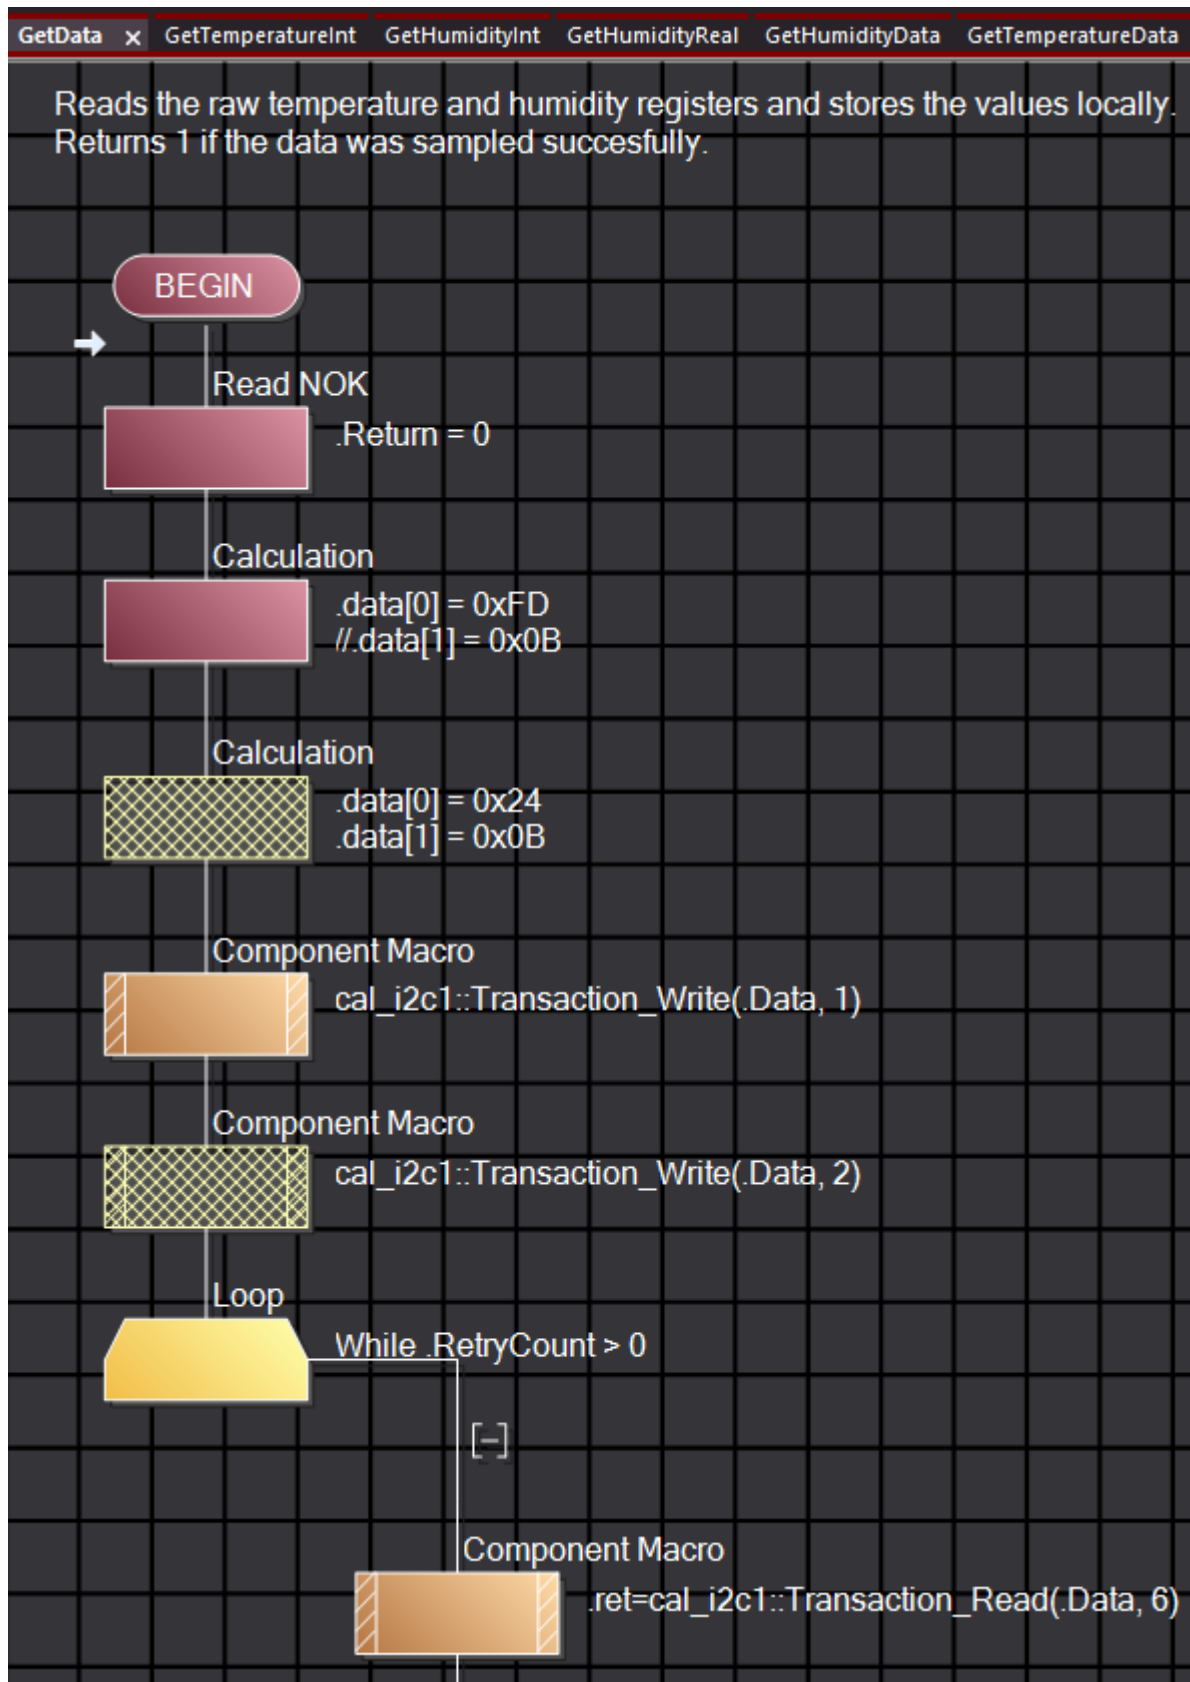
Change the init, it need's only 1Byte to write with 0xFD

Chane register to read to 0xFD (0X24 is a bad register, it starting the heater of the Sensor)

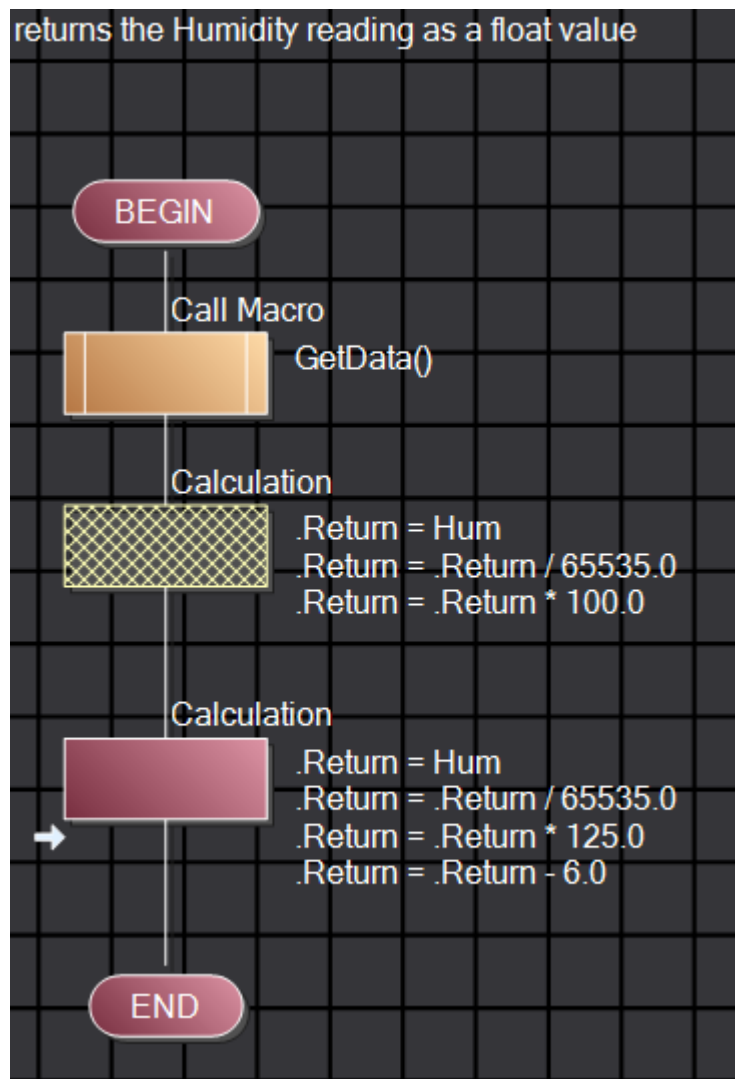
Change the Humidity calculation, it's different to the SHT31

Change the address selector. SHT41 has not a pin for the address, but the sensor is available with different address.

068 ADDR A 0x44  
069 ADDR B 0x45  
070 ADDR C 0x46

068 ADDR VSS 0x44  
069 ADDR VDD 0x45
